# PAKISTAN AIRPORTS AUTHORITY

## **Construction of New Air Traffic Control Tower (ATCT), Fire Station and Allied Facilities at Skardu International Airport, Skardu**

### ***Consolidated Responses to Prospective Bidders' Pre-Bid Queries***

*(Pre-Bid Meeting held on 13 August 2026 — Bidding Document published on EPADS on 27 July 2026)*

VEHICLE SERVICE PIT - STRUCTURAL  
DETAILS

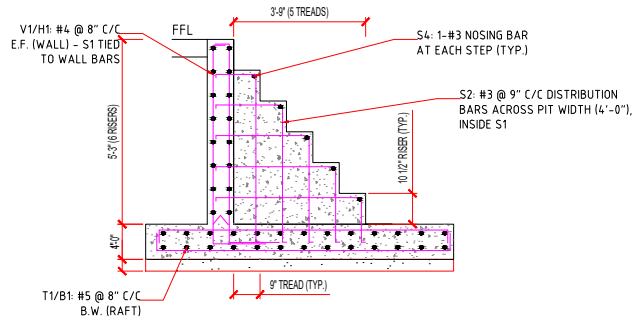
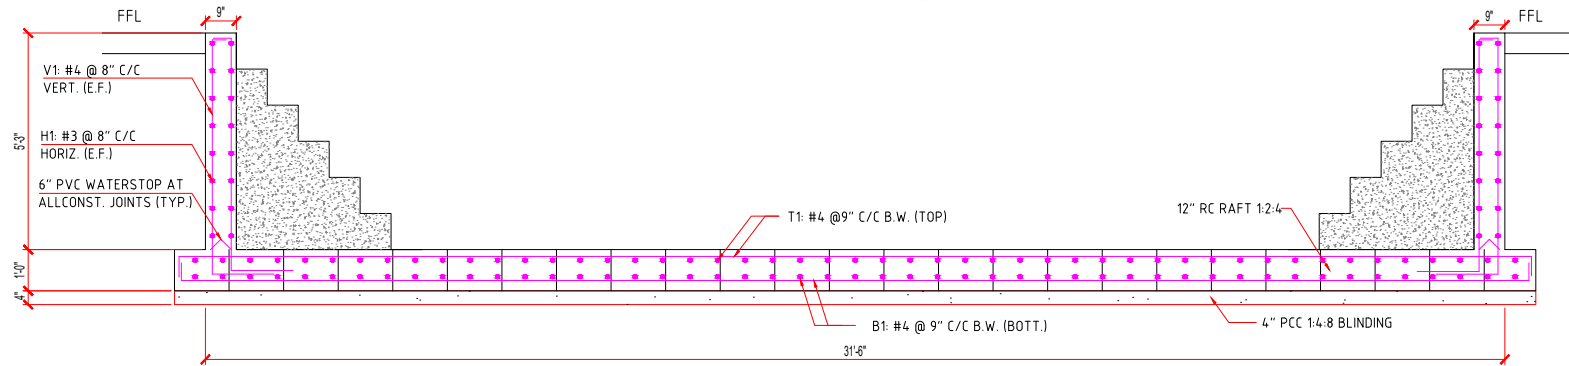
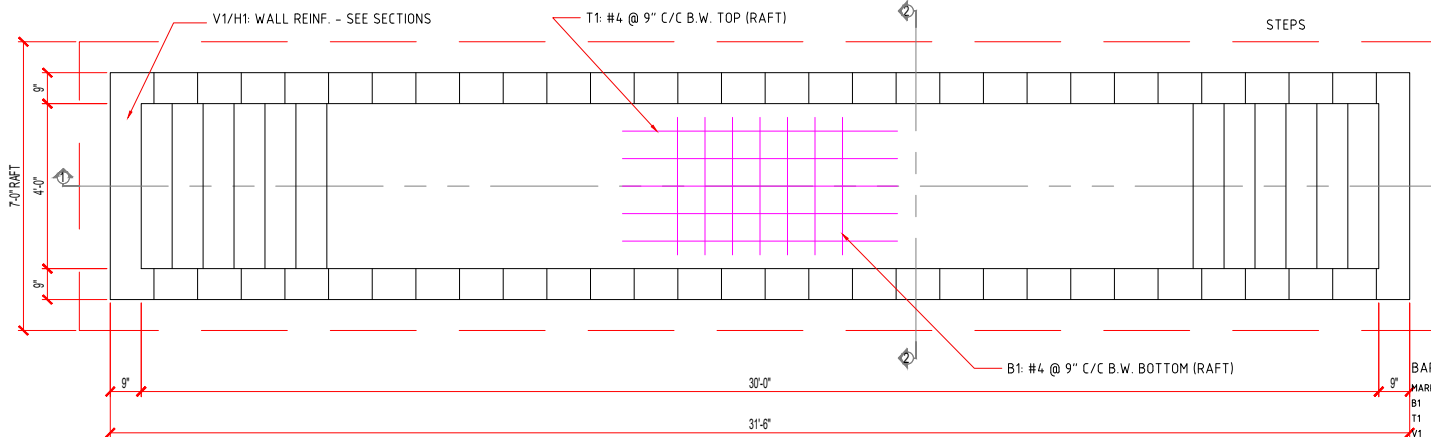
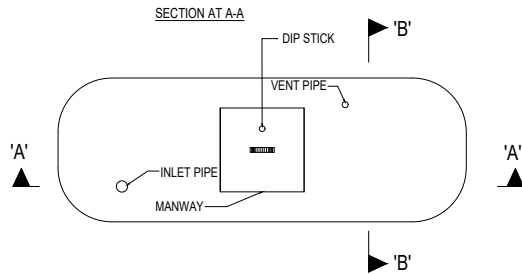
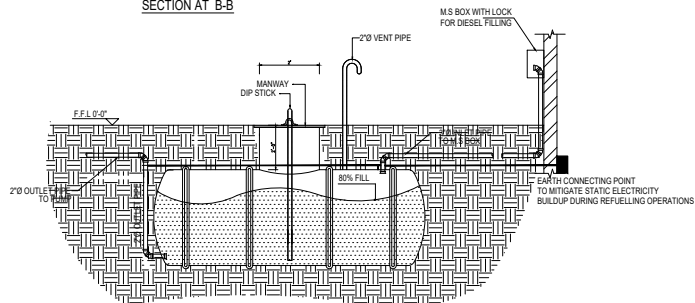
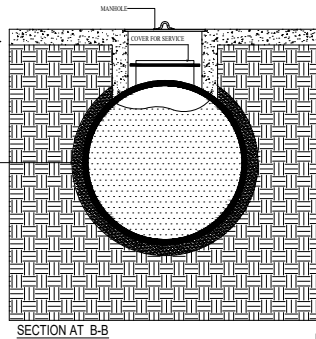
| S. No. | Query                                                                                                                                                                                                                                                                                        | Reply                                                                                                                                                                                                                                                                                                                                                                                                                                                                                                                                                                                                                                                                                                                                              |
|--------|----------------------------------------------------------------------------------------------------------------------------------------------------------------------------------------------------------------------------------------------------------------------------------------------|----------------------------------------------------------------------------------------------------------------------------------------------------------------------------------------------------------------------------------------------------------------------------------------------------------------------------------------------------------------------------------------------------------------------------------------------------------------------------------------------------------------------------------------------------------------------------------------------------------------------------------------------------------------------------------------------------------------------------------------------------|
| 32     | BOQ Item CB-23 (Reinforced Concrete), measured in “Job”: the location and extent of the work are not defined. Request the structural members, grade and reinforcement details, and revision of the unit of measurement to a measurable quantity.                                             | BOQ Item CB-23 is a single, defined-scope composite item for <b>vehicle service pit</b> (raft, walls and stair, together with associated waterproofing, water-stops, plaster and floor/wall finishes) relating to a specific below-grade structure shown on the Architectural drawings (Drawings No. AW-29a ) & Structural Drawing (S-40) are attached herewith.                                                                                                                                                                                                                                                                                                                                                                                   |

#### DIESEL TANK SECTION DETAIL

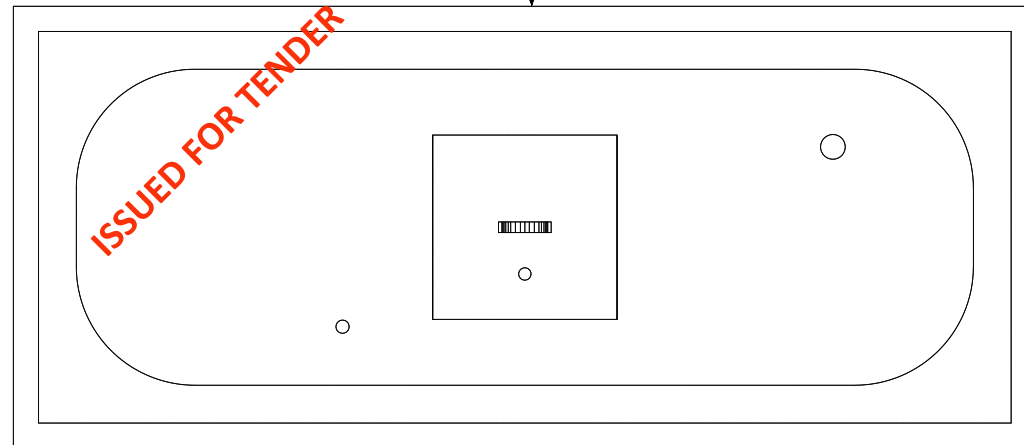
| 46 | BOQ Item CB-25 (Diesel Fuel Storage Tank): drawings and detailed specifications not available.                                                                        | <p>The technical requirements for the underground diesel fuel storage and supply system (tank design per DIN 6608/6616, corrosion allowance, coating, dyking/bunding, instrumentation, piping and controls) are set out in full at Volume II – Technical Specifications, Section 0680, to which bidders are directed.</p> <p>A dedicated layout/capacity drawing for the underground storage is attached herewith.</p> |

| Drawing No. | E-66        |

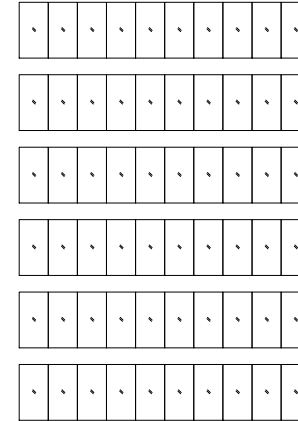
| 109 | Bill 7 – Solar System: confirm whether the specified 250 kW capacity is stated before or after altitude/temperature derating.                                                                                      | <p>It is clarified, in the first instance, that the Solar PV system is priced under BOQ Item E-13.01, Bill 5 – Electrical (not Bill 7), which specifies “Monocrystalline PV modules 250 kW.” This 250 kW figure is the array's nameplate (STC, standard test condition) DC capacity, before altitude, temperature and other site-condition derating.</p> <p>The Contractor's design shall apply the applicable altitude/temperature/soiling derating factors when sizing the inverter(s) and confirming expected net AC output, consistent with the drawing note on Sheet E-66 referring to an approximately 75% average system efficiency.</p> <p>Please refer to Drawing No. E-66 (Rev.) is attached herewith.</p> |

DRAWING TITLE:  
AIRSIDE SERVICE ROAD DIRECTIONAL  
AND RESTRICTION SIGNBOARDS

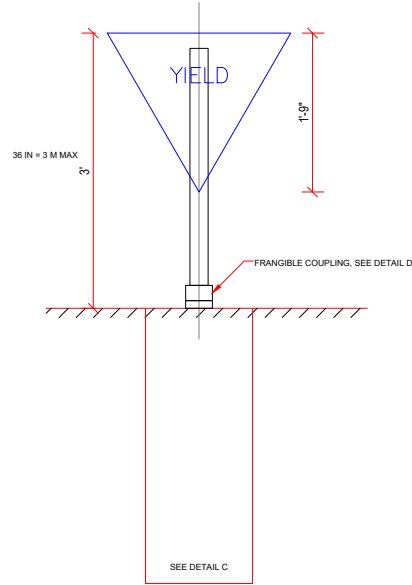
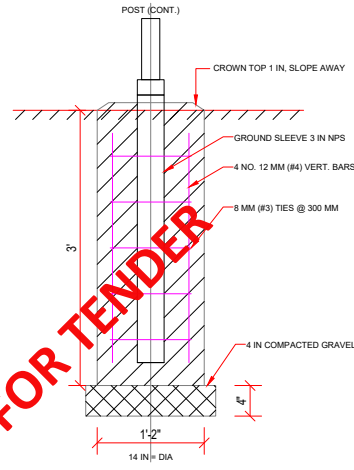
| 65 | BOQ Item R-23 (Sign Boards): request detailed drawings, quantities and material specifications for all sign-board types.                                                                                                                                       | Please refer to Drawing No. R-36 & R-37 in attached herewith for ready reference.                                                                                                                                                                                                                                                                                                                                                                                                                                                                                        |
